**ADDENDUM NO. 2**

DATE: **FEBRUARY 14, 2012**  
PROJECT: **GULF SHORES FIRE STATION**  
LOCATION: **GULF SHORES, ALABAMA**

SHEET NO:  
**G13  
A300.4**  
PROJECT NO: 11-011

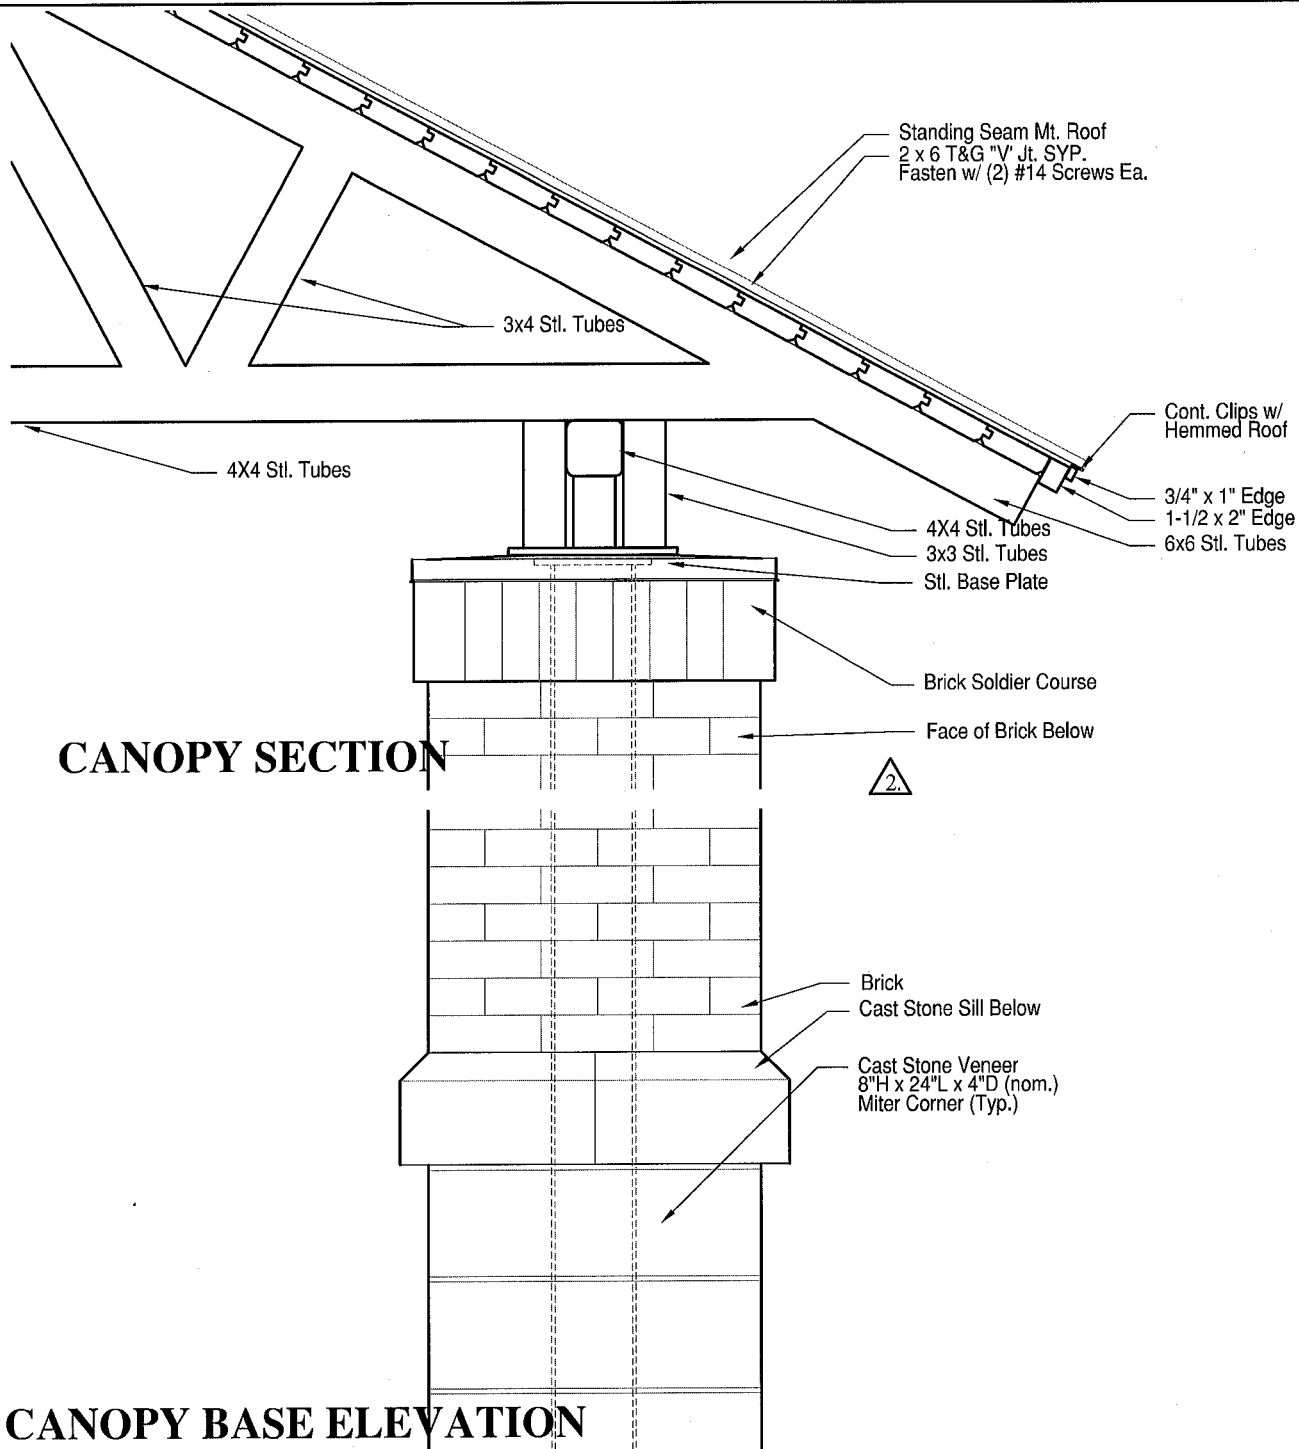
**Refer to Details G13,K13,N13/A300.4 and E1/A300.8-**

1. Columns have been changed to 2'-0" Typical.
2. Face of Brick shall align with Face of Stone Below.
3. Contractor's Option: Stone Units sized as 8"H x 24"L x 4"D are acceptable in lieu of that shown.
4. Outside Corners are to be Mitered. Sill Blocks to be Mitered or Preformed Corners used.

General: It is the intent by this change to reduce overall cutting of masonry where possible. Where cast stone, sill blocks and brick are shown, it is intended that the face of the stone below the sills be moved into alignment with the back of the sills and the face brick above. All dimensions are nominal. Other coordination will be handled by the shop drawings.
